MR1115-383

Application Serial No. 10/082,275

Responsive to Office Action dated 12 February 2004

AMENDMENTS TO THE DRAWINGS

FIG.5

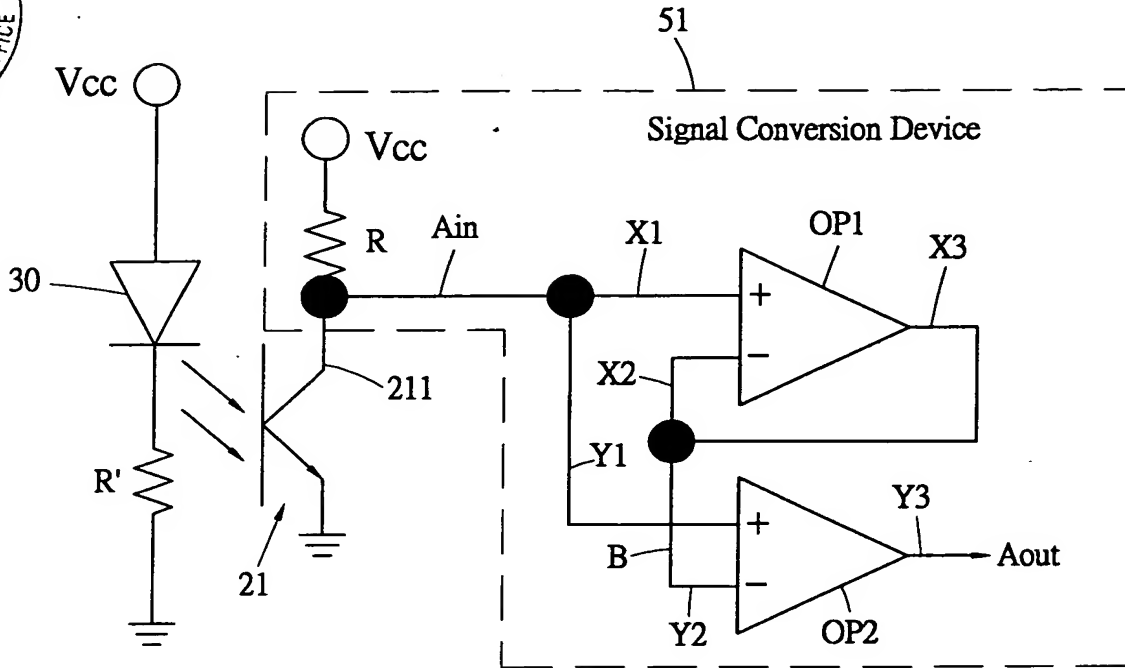
The attached sheet of Drawings includes changes to Fig. 5. This sheet, which includes Figs. 5, 6, and 7, replaces the original sheet including Figs. 5, 6, and 7. In Fig. 5, the "Signal Conversion Device" has been amended to correct typographical errors.
